STATE OF CONNECTICUT  
CONNECTICUT SITING COUNCIL

APPLICATION OF MESSAGE CENTER  
MANAGEMENT, INC. (MCM) AND NEW CINGULAR  
WIRELESS (AT&T) FOR A CERTIFICATE OF  
ENVIRONMENTAL COMPATIBILITY AND PUBLIC  
NEED FOR THE CONSTRUCTION, MAINTENANCE  
AND OPERATION OF A TELECOMMUNICATIONS  
TOWER FACILITY IN REDDING, CONNECTICUT

DOCKET NO. 449

RESPONSES OF MESSAGE CENTER MANAGEMENT  
AND NEW CINGULAR WIRELESS  
TO CONNECTICUT SITING COUNCIL PRE-HEARING QUESTIONS, SET I

# Avian Resources Map

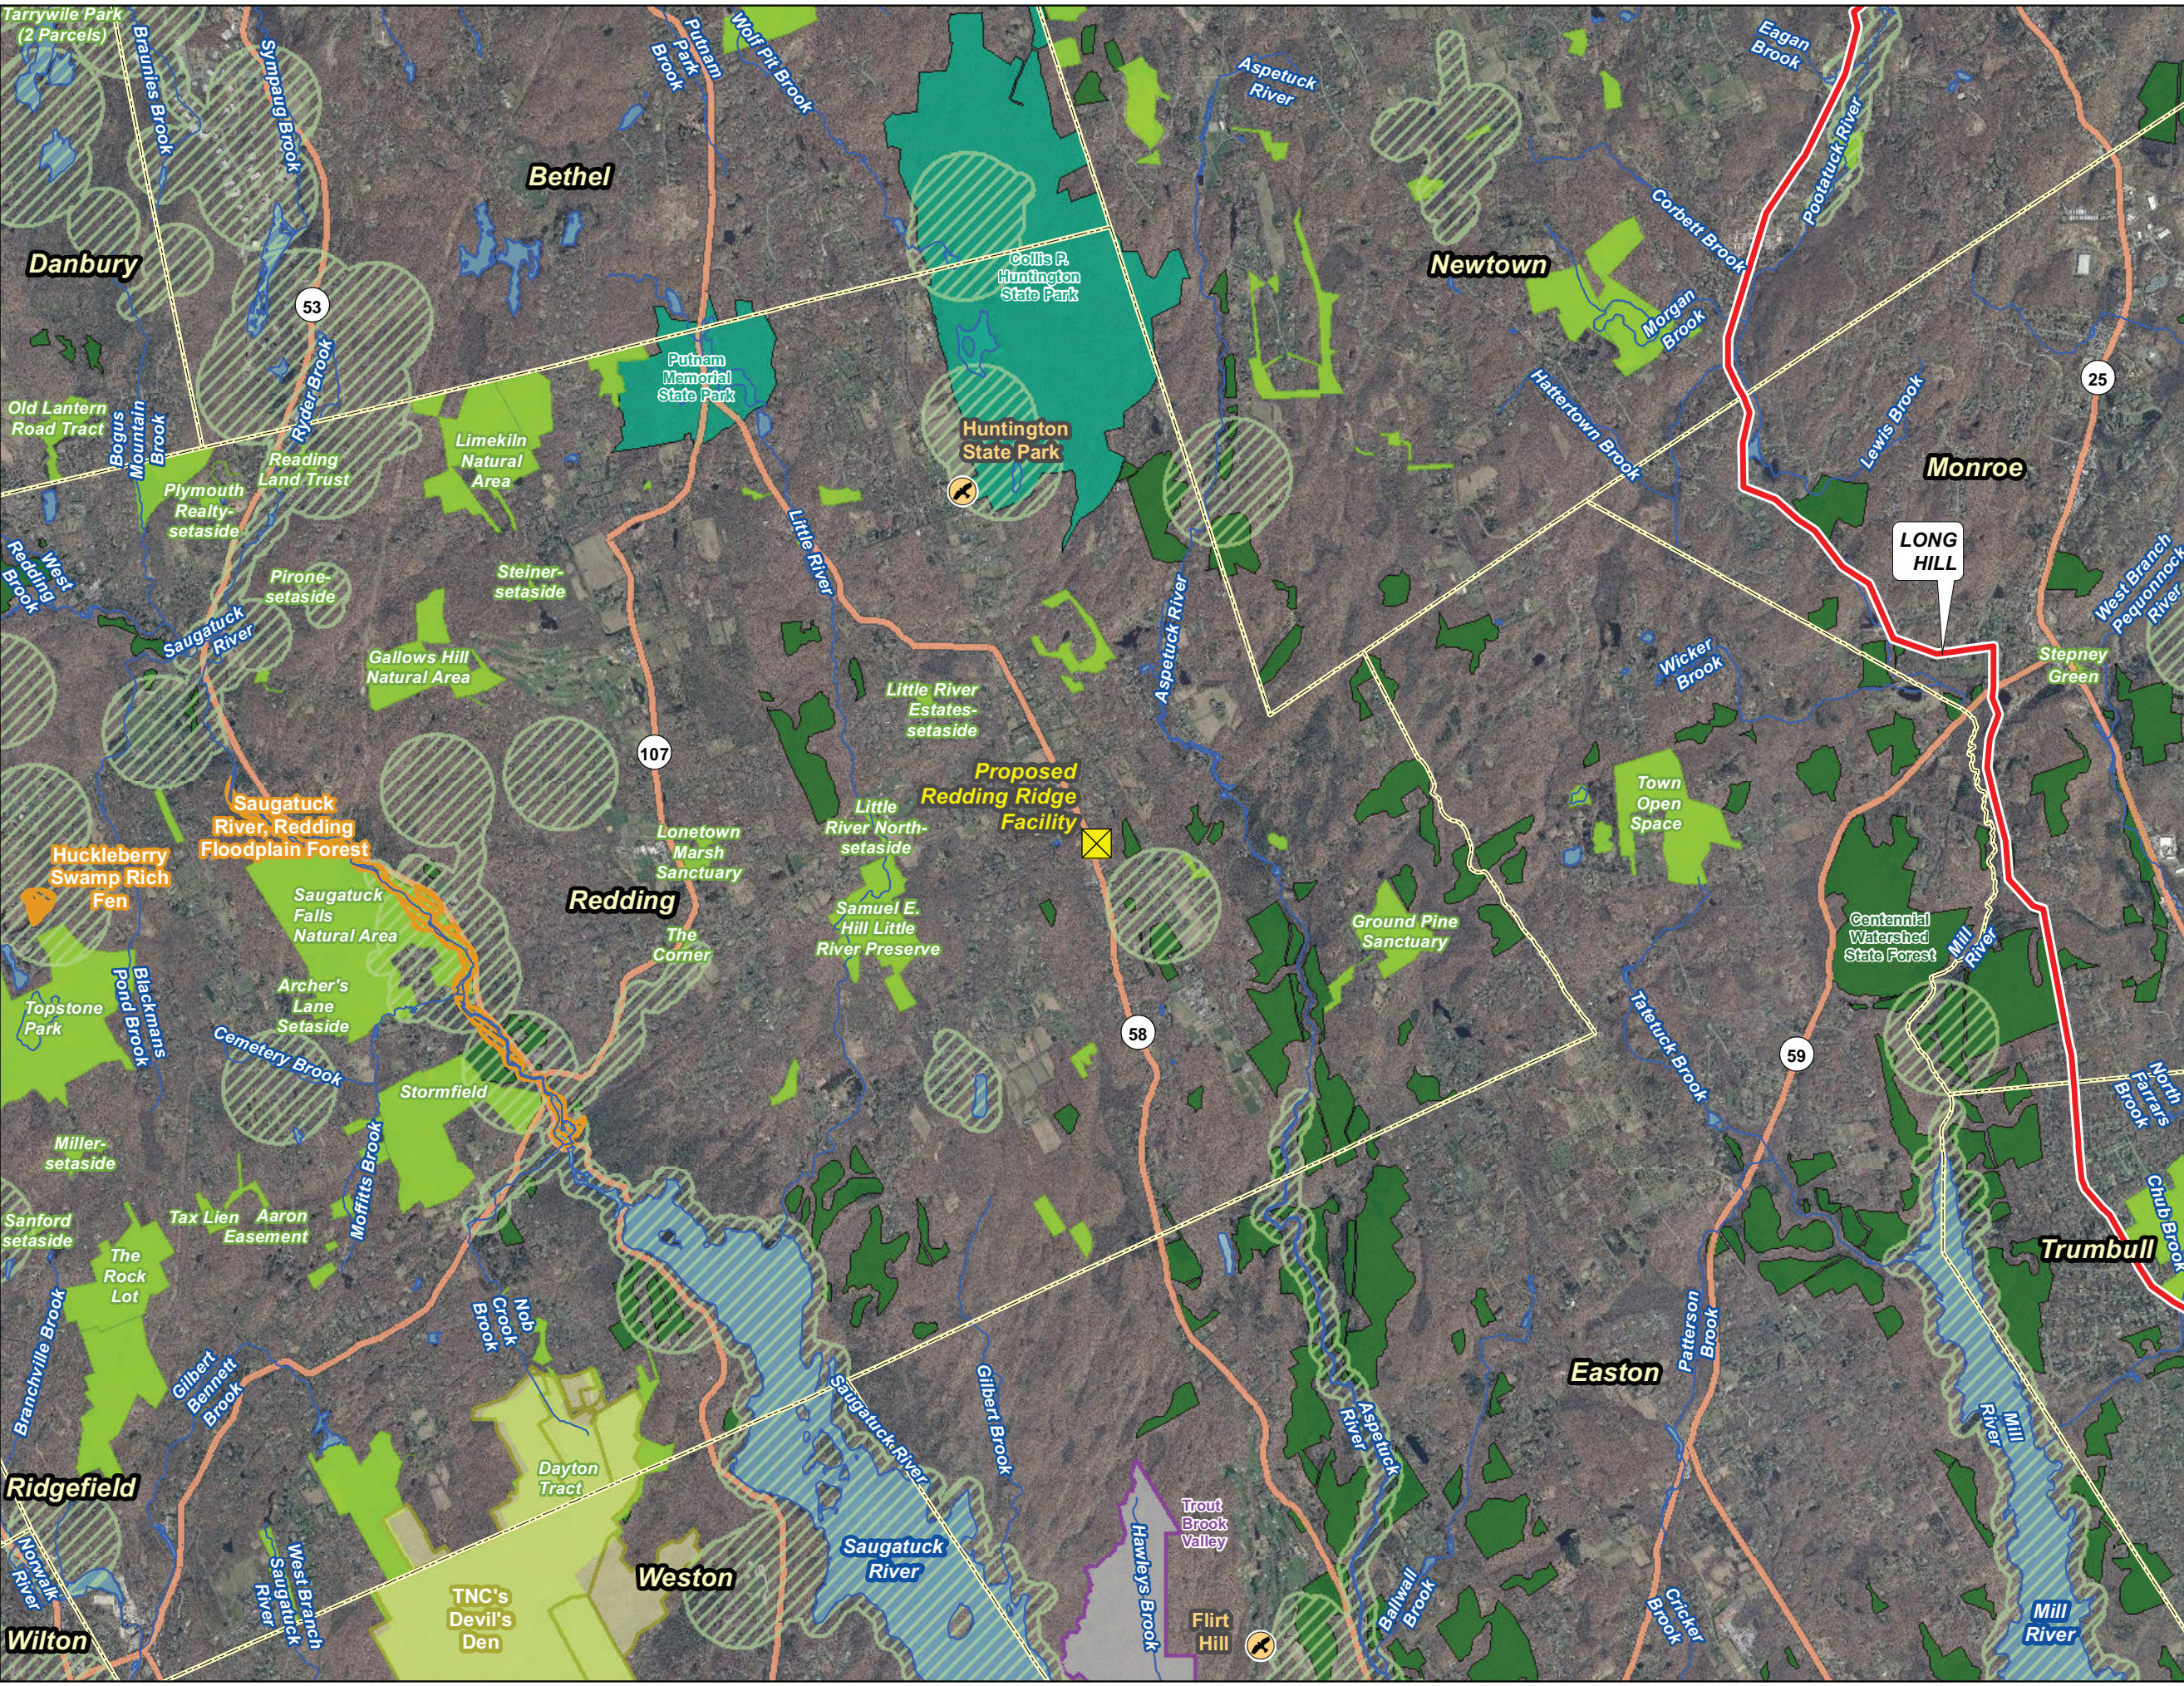
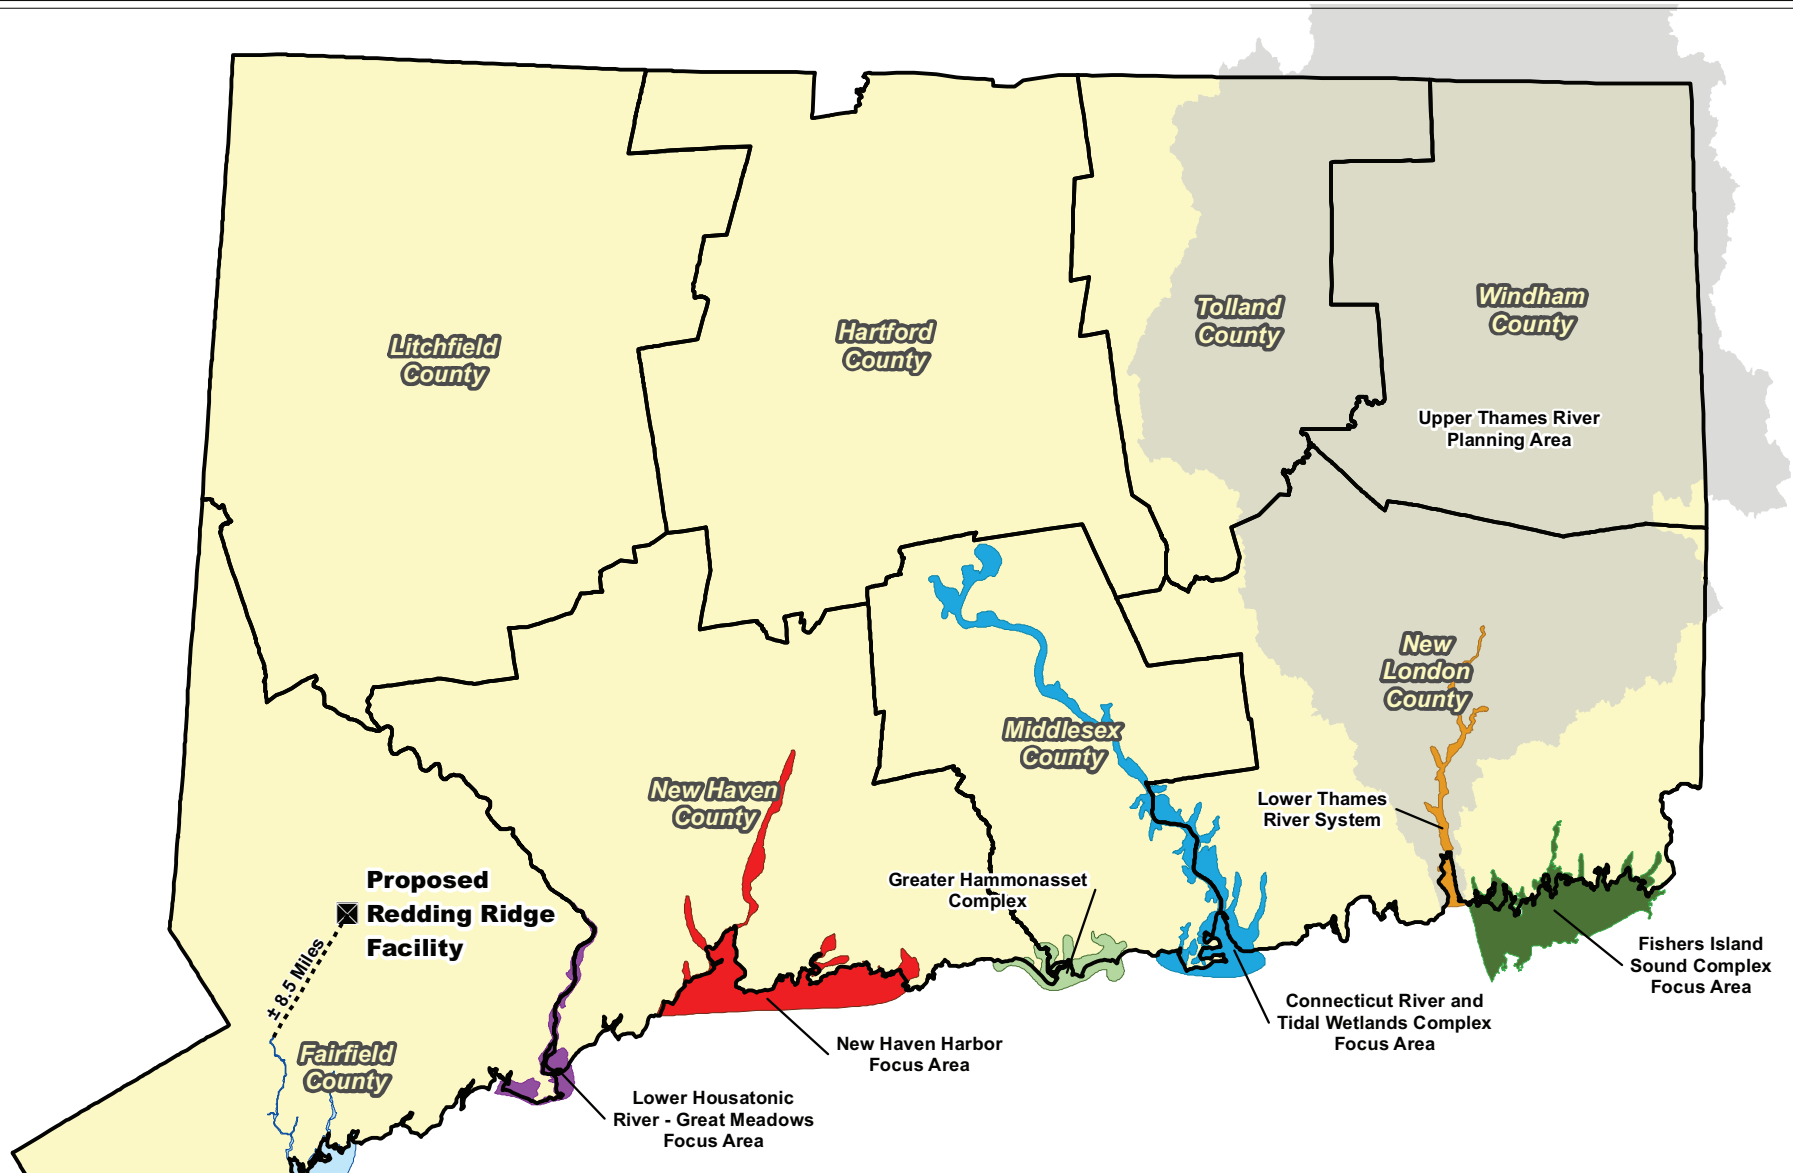
Q43. Is the proposed site near an "Important Bird Area" as designated by the National Audubon Society?

Q44. Would AT&T's proposed facility comply with recommended guidelines of the United States Fish and Wildlife Service for minimizing the potential for telecommunications towers to impact bird species?

A43. *No. The nearest Important Bird Area to the proposed site, The Nature Conservancy's Devil's Den Preserve in Weston and Redding, is located approximately 4.6 miles to the southwest. Please see analysis provided as Attachment 9.*

A44. *Yes. Please see analysis provided as Attachment 9.*
